**CENTER FOR DRUG EVALUATION AND
RESEARCH**

APPLICATION NUMBER:

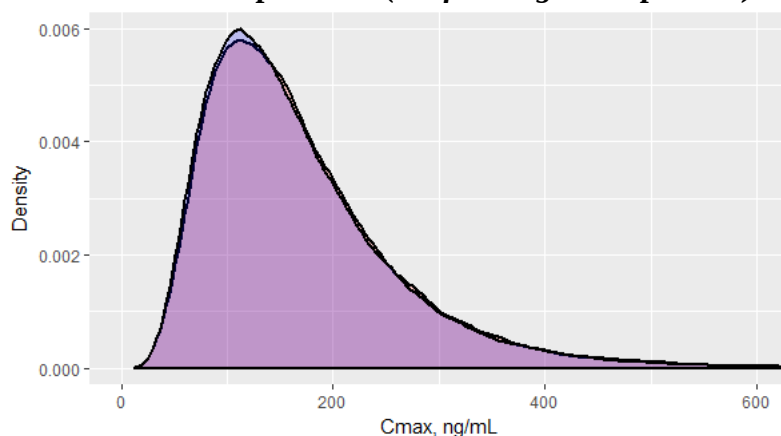
Sponsor Response: *The sponsor would like to discuss the collection and characterization of heart rate and blood pressure data in the vibegron clinical program.*

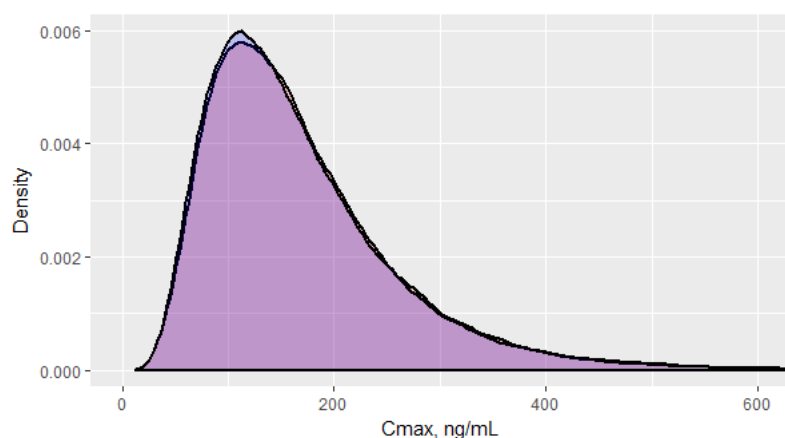
Sponsor Response: The sponsor would like to discuss the collection and characterization of heart rate and blood pressure data in the vibegron clinical program.
